**OPTIONAL SERVICE BULLETIN NO. DAC1-27-05 REV. 1**  
**SUPERSEDES DAC1-27-05 REV. 0**

Type: DA20-C1

Replacement of the flap actuator and installation of the flap resistor assembly.

Figure 1. Flap controller on the non-G500 instrument panel

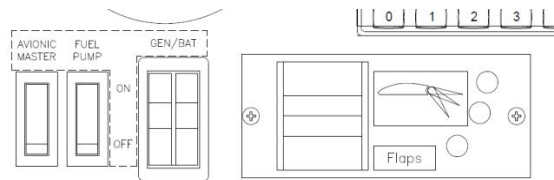
1. Make sure that the latest revision of the Service Bulletin No. DAC1-27-04 - Installation of the Diamond Aircraft flap control module unit and micro switch tray is incorporated. Otherwise, do the following steps:
  - A. Remove the instrument panel cover. Refer to AMM Section 25-10.
  - B. Remove the flap controller from the instrument panel.

- C. Plug the flap controller connector on the instrument panel harness into the Diamond Aircraft flap controller (item 17), and install it into the same location as the previous controller.

Figure 2. Flap resistor assembly attachment points (looking aft).

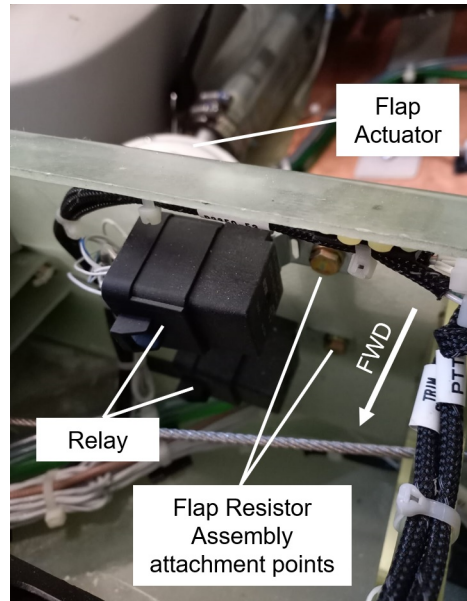
13. Identify the attachment points to install the flap resistor assembly (item 15). Remove the bolts, washers, and self-locking nuts of the attachment points. Refer to Figure 2.

NOTE: The attachment points of the flap resistor assembly attach two existing relays (Figure 2). If MOD 0037 Pitot Heat is installed, the upper attachment point attaches the pitot heat relay (Figure 3).

14. Install the bolts (item 11), washers (item 12), bushings (item 14) and self-locking nuts (item 13) which attach the flap resistor assembly (item 15), and the two relays (three relays if MOD 0037 Pitot Heat installed). Refer to Figures 2 and 3.

Figure 3. Flap actuator and flap resistor assembly installation

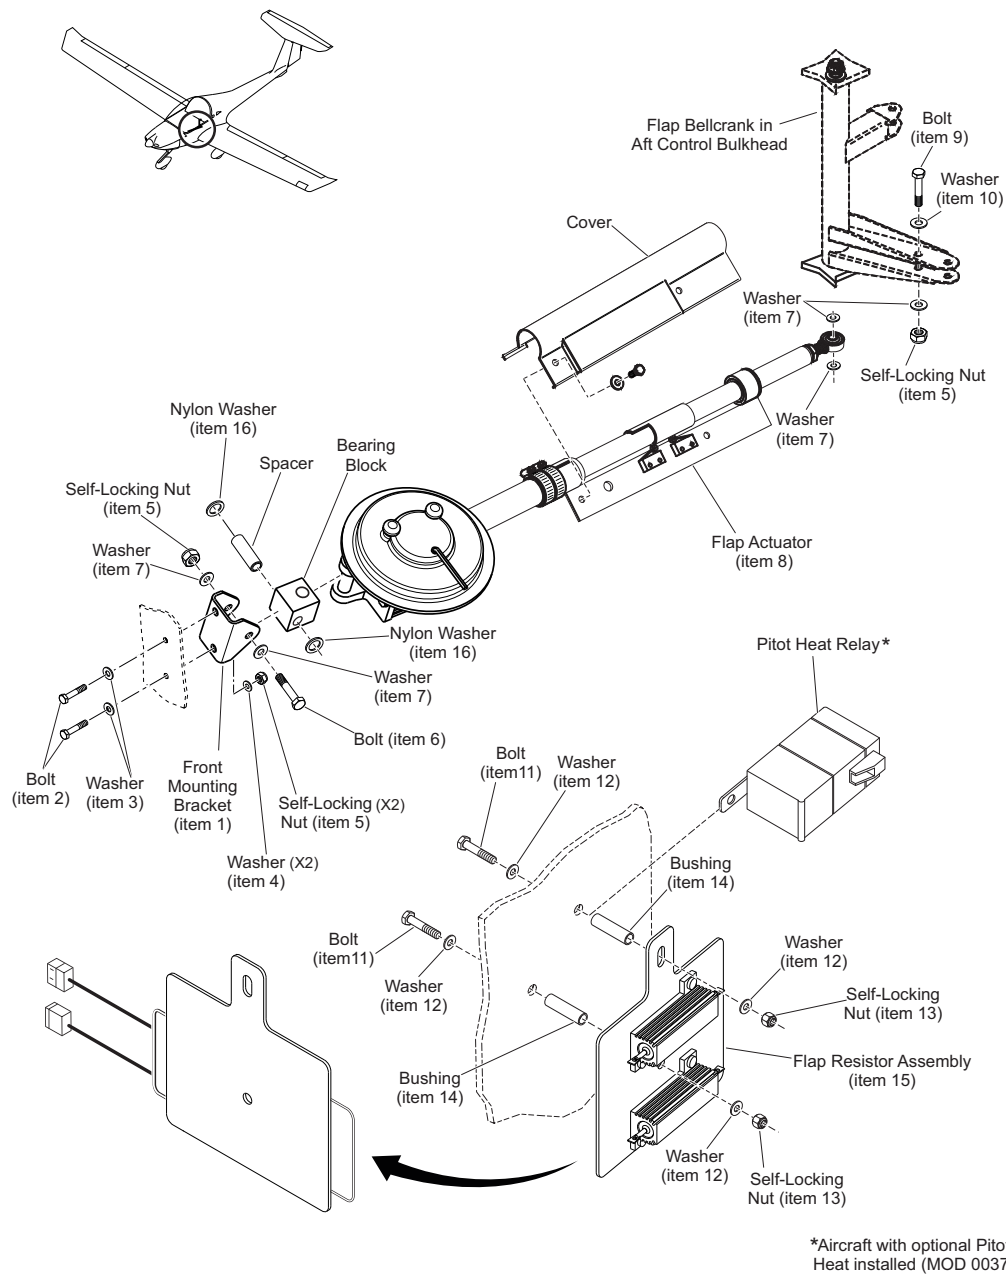
1. Incorporate AMM-TR-MÄM-22-0016 into the Airplane Maintenance Manual or use an AMM revision in which AMM-TR-MÄM-22-0016 has been incorporated.
2. Remove the existing flap actuator. Refer to AMM Section 27-50.
3. Remove the bearing block from the existing flap actuator. Refer to Figure 3.
4. Remove the bolts, washers and self-locking nuts which attach the front mounting bracket. Refer to Figure 3.
5. Remove the existing front mounting bracket from the aircraft.

6. Make sure that the new front mounting bracket (item 1) will be installed on a flat surface of the composite.
7. Install the bolts (item 2), washers (items 3 and 4), and self-locking nuts (item 5) which attach the new front mounting bracket (item 1) to the aircraft. Refer to Figure 3.

8. Apply Aero Shell Grease 22 to the spacer and the bearing block. Refer to Figure 3.
9. Install the bearing block to the new flap actuator (item 8). Refer to Figure 3.

10. Put the spacer and the nylon washers (item 16) in the installation position. Refer to Figure 3.
11. Install the bolt (item 6), washers (item 7), and the self-locking nut (item 5) which attach the new flap actuator (item 8) to the to the new front mounting bracket (item 1). Refer to Figure 3.
